Rezoning Transportation Analysis

Petition Number 2016-061 **Updated** 4/22/2016

Location Approximately 26.56 acres located on the northeast corner at the intersection of Wilora Lake Road and Venedale Road.

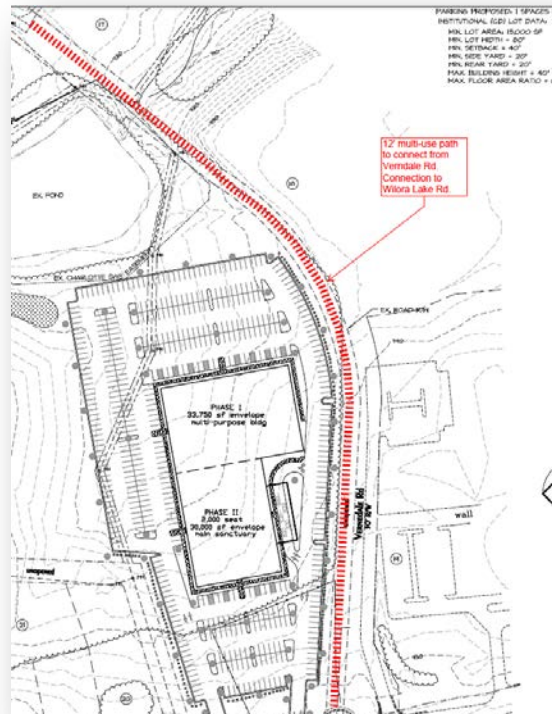
1. CDOT requests that the petitioner eliminate one of the proposed driveway connections to Wilora Lake Rd.
2. The petitioner should remove the cul-de-sacs as part of the proposed street extension of Wilora Lake, and reconnect the existing driveways to Wilora Lake.
3. CDOT requests that the petitioner install a 12' multi-use path in the existing right of way for Verndale Rd. This connection would be similar to as shown below: (CDOT is ok with 10' after discussions with petitioner)
